**CITY OF BOULDER
PLANNING BOARD MEETING AGENDA**

DATE: February 27, 2014

- B. **2nd CONCEPT PLAN REVIEW AND COMMENT:** Request for public and Planning Board comment on a proposal for the redevelopment of 2930 Pearl Street (case no. LUR2014-00011); this is a Second Concept Plan Review, requested by the Planning Board at the first review public hearing was on Nov. 7, 2013 (case no. LUR2013-00045. Proposal is for the redevelopment of the property generally located at the southwest corner of 30th and Pearl streets (2920 and 2930 Pearl St., 2077-2079 and 2111 30th St.) with three new four story buildings of 100,000 square feet each for a total of 300,000 square feet for corporate offices with below grade parking.

- C. **Public hearing and consideration of a Site Review application for 1301 Walnut Street**, referred to as the Wencel Building, case no. LUR2013-00053, to redevelop the site including the existing surface parking lot on the site with a new four-story building. The project site includes the existing buildings referred to as the former James Hotel and the former Peyton Insurance Company building, not planned for redevelopment as well as the existing Colorado Building, also

Figure 1: Guideline 2.6.C. and West Elevation of Proposed Project

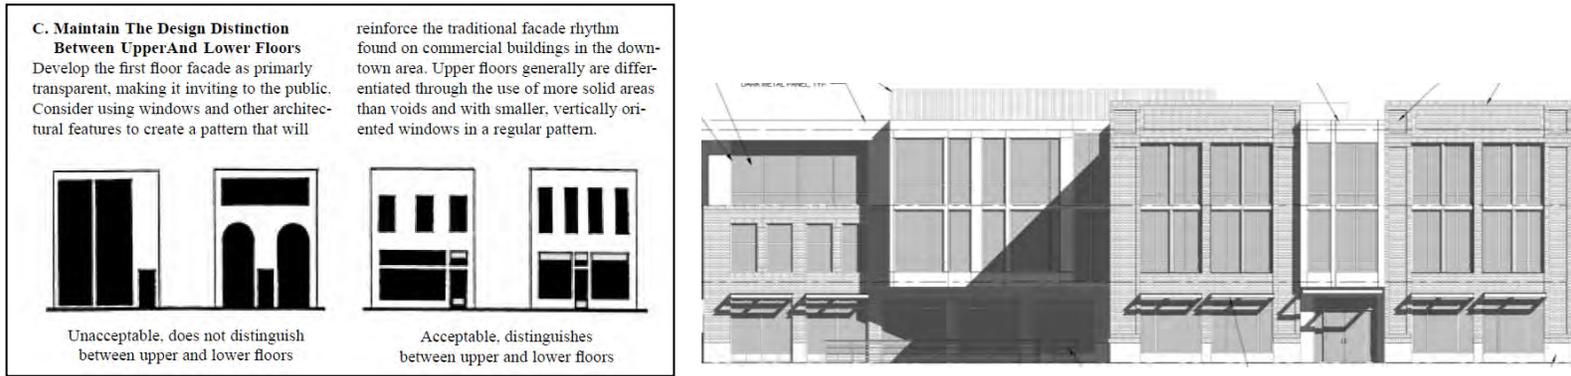
Guidelines as currently proposed. Staff recommends revisiting the window openings and suggests looking to other more historically compatible solutions to the windows to still allow for significant light and air while still ensuring compatibility. In particular, guideline 2.6.C suggests “use of more solid areas than voids and with smaller, vertically oriented windows in a regular pattern.”

Figure 2: South Elevation superimposed with Colorado Building

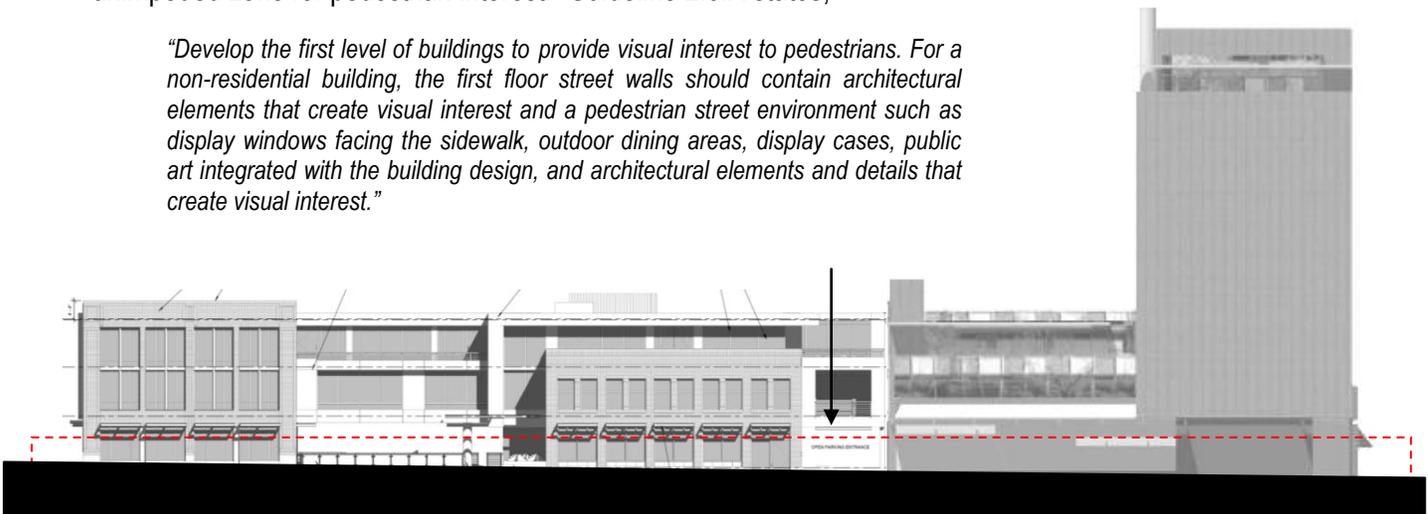
“Develop the first level of buildings to provide visual interest to pedestrians. For a non-residential building, the first floor street walls should contain architectural elements that create visual interest and a pedestrian street environment such as display windows facing the sidewalk, outdoor dining areas, display cases, public art integrated with the building design, and architectural elements and details that create visual interest.”
